Contract #: 04-0120F4Cty: SF/ALA Rte: 80 PM: 13.2/13.9File #: 69.25B**QUALITY ASSURANCE -- NON-CONFORMANCE REPORT****Location:** Changxing Island, Shanghai, PRC**Report No:** NCR-000409**Prime Contractor:** American Bridge/Fluor Enterprises, a JV**Date:** 15-Sep-2009**Submitting Contractor:** Zhenhua Port Machinery Company, Ltd (ZPMC), Changxing Island**NCR #:** ZPMC-0383**Type of problem:**

Reference Description: Missed MT indications on East Tower, Lift 1**Description of Non-Conformance:**

Subject: NCR No. ZPMC-0383

Job Name: SAS Superstructure

焊缝返修位置示意图：

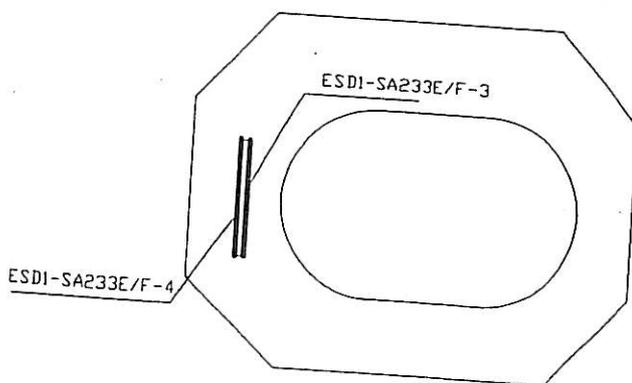
东塔第一吊装段报验时，发现B面板踏步板2条裂纹，长度分别为10MM，5MM.具体如图：
During inspection first lifting east tower, two cracks were found at Skin B, 10mm and 5mm in length, the details sees the following draft.

阴影处为需要补焊区域 Repair area in shadow.

1. 火焰加热时, 水汽没有完全的去掉或者这个区域预热不够;
1. Moisture wasn't completely removed during drying operation (preheating) or the area wa sn't preheated sufficiently.

1. QC 须监控碳刨、打磨和焊接过程
 2. 碳刨去除缺陷并打磨光滑
 3. VT 检测以确保缺陷被清除
 4. 焊接须符合 WPS 要求
 5. 在进入下道焊缝前, QC 须确保所有焊渣都已被去除干净
 6. 打磨返修区域使其与临近焊缝或母材齐平
 7. 对返修区域进行 VT, MT 和 UT 检测
-
1. QC shall monitor gouging/grinding/welding
 2. Gouge defects & grind smoothly
 3. Verify that defects have been removed with VT
 4. Welding shall be in accordance with WPS
 5. QC shall ensure all slag is removed prior to deposition of subsequent weld passes
 6. Blend repair area with adjacent base metal
 7. Perform VT, MT, & UT to repaired area

1. QC shall verify sufficient preheat has been applied, to remove moisture, prior to welding.
